Subject: **GUANERI SUBDIVISION**
Town of Chester, New York

WSP USA Corp. (WSP) has reviewed the Sketch Plan for the Guaneri Subdivision in the Town of Chester. Our recommendations are based on the following:

Overview

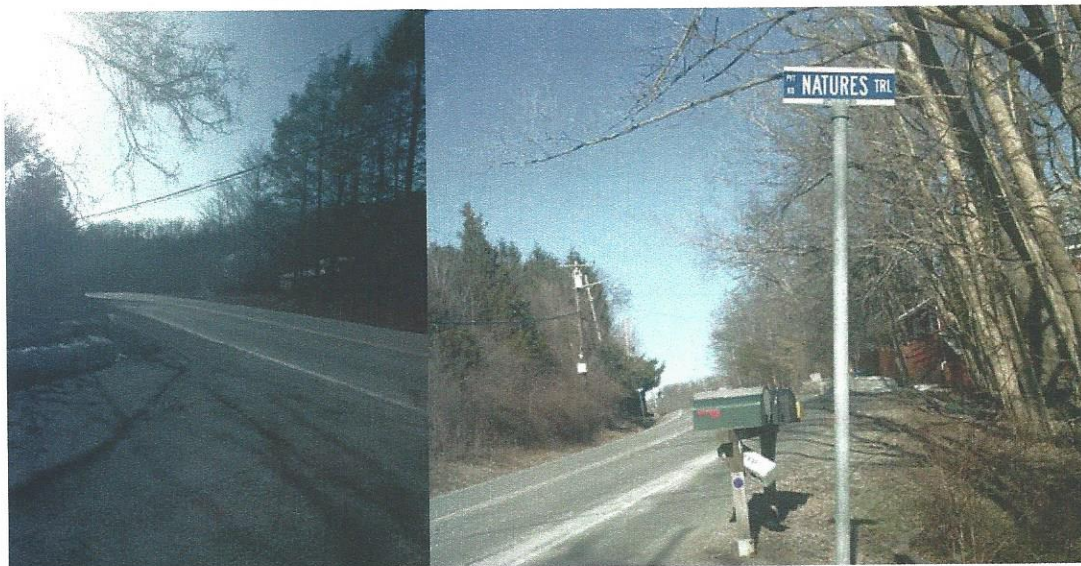
The project site is located on Nature's Trail in The Town of Chester, New York. Nature's Trail forms a T-intersection with Gibson Hill Road, which serves as a connection for the Town of Chester and Monroe to The Town of Warwick. Nature's Trail is controlled by a stop sign to Gibson Hill Road and has limited sight distance in both directions.
